### HD I/O Option Board Owner's Guide Errata

The Silicon Graphics *HD I/O Option Board Owner's Guide* (007-3968-001) has the following errors:

**Figure 2-6** Fields and Frames for SMPTE 274

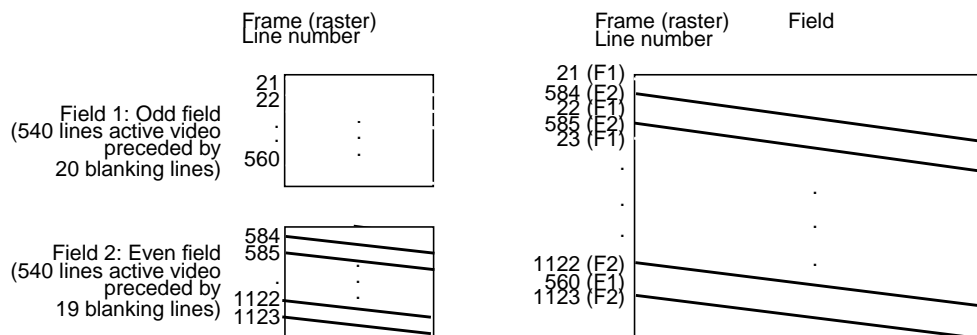
- In Chapter 2, the section "Field Dominance" contains errors: Figure 2-6 is incorrect, as is the second paragraph after it. The correct version of the figure is shown below.

The paragraphs after the figure should read as follows:

Editing is usually on Field 1 boundaries, where Field 1 is defined as the first field in the video standard's two-field output sequence. However, some users may want to edit on F2 boundaries, which fall on the field in between the video standard's frame boundary. To do so, use this control, then program your deck to select F2 edits.

A set of frames to be output must be deinterlaced into fields differently, depending on the choice of output field dominance: for SMPTE 274M, the top line is in F1, as shown in Figure 2-6; for SMPTE 240M, the top line is in F2. For example, when F1 dominance is selected, the field with the topmost line must be the first field to be transferred; when F2 dominance is selected, the field with the topmost line must be the second field to be transferred.
